Access Compliance Report

Public Rights-of-Way

Intersection ID: 3683	Main Street: BROMPTON_LN	Cross Street: DAVIS_LAKE_PY	Location: SW
ADA ID: 98F7CF3C7485	Ramp Type: Perp	Initial Pass/Fail: Fail	Overall Compliance: No
		Severity Score: 10

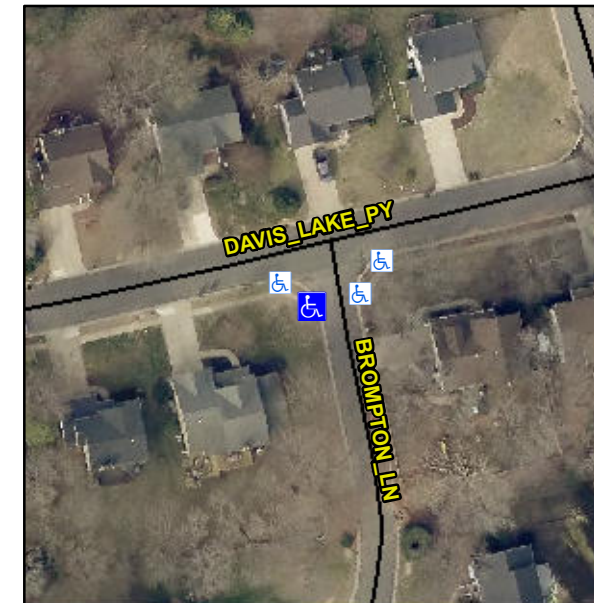
Not Found, R304.5.1, R304.5.3

Compliance	Description	Data	Compliance	Description	Data
N/A	Ramp Length (in)	51.0	Yes	Ramp Slope (%)	8.2
No	Ramp Width (in)	42.5	No	Ramp XSlope (%)	2.2
N/A	Flare Type LT	N/A	N/A	Flare Type RT	N/A
N/A	Flare Slope LT (%)	N/A	N/A	Flare Slope RT (%)	N/A
N/A	Flare Traversable LT?	N/A	N/A	Flare Traversable RT?	N/A
N/A	Landing Length (in)	N/A	N/A	DWS Provided?	N/A
N/A	Landing Width (in)	N/A	N/A	DWS Contrast?	N/A
N/A	Landing Slope (%)	N/A	N/A	DWS Length (in)	N/A
N/A	Landing X Slope (%)	N/A	N/A	DWS Full Width?	N/A
N/A	Landing Curb? (Y/N)	N/A	N/A	DWS Offset (in)	N/A
N/A	Shared Landing?	N/A			
N/A	Gutter Ponding?	N/A	N/A	Gutter Slope (%)	N/A
N/A	Gutter Lip Ht (in)	N/A	N/A	Gutter X Slope (%)	N/A
N/A	Painted X Walk1?	No	N/A	Painted X Walk2?	N/A
	X Walk 1 Direction	To E		X Walk 2 Direction	N/A
N/A	X Walk 1 Width (in)	N/A	N/A	X Walk 2 Width (in)	N/A
	X Walk 1 Slope (%)	0.8		X Walk 2 Slope (%)	N/A
	X Walk 1 X Slope (%)	2.2		X Walk 2 X Slope (%)	N/A

Remove & Replace Entire Ramp.
